**Addendum No. 04**

**Subject:** William C. Bryant School  
SDP Contract No. B-027C OF 2020/21 – Electrical Construction  
William C. Bryant School  
**Location:** 6001 Cedar Ave  
Philadelphia, PA 19143

**APPENDIX      : Hoffman Enclosures for Wireless Access Points**

Figure 1. Front view. Overall box dimensions: 12 inches x 10 inches x 6 1/4 inches (approx.)

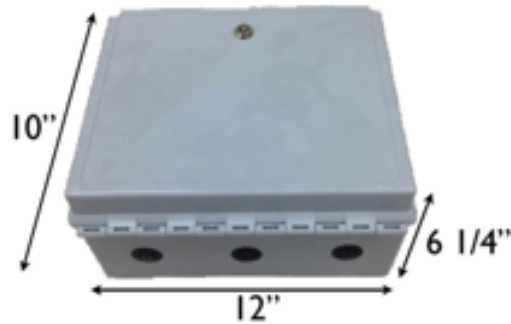
2. Part number for boxes with locks: A12106CHSCFG W/Lock/PNL/LAT

Figure 2. Exterior bottom vent dimensions.

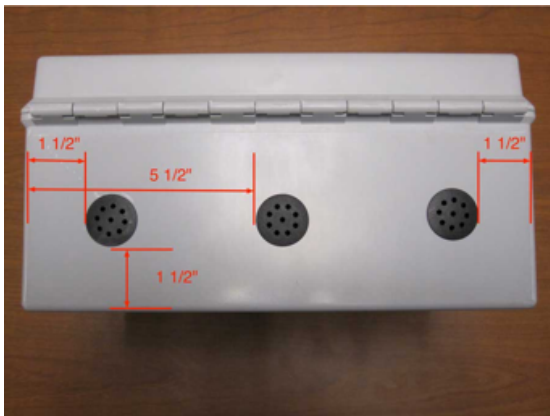
3. The boxes are to be provided with (6) vent plugs on the sides of the box to allow for proper air flow. Vent plugs part number: Micro Plastics #62MP1000V

4. Plugs should be held in place with adhesive or silicone.

Figure 5. Interior view of CAT6 termination.

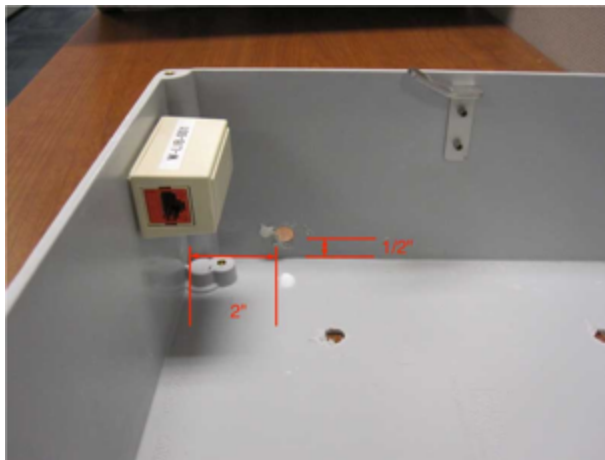
5. The CAT6 cable should penetrate the enclosure through the top-rear-left corner to be terminated on a biscuit jack as shown.
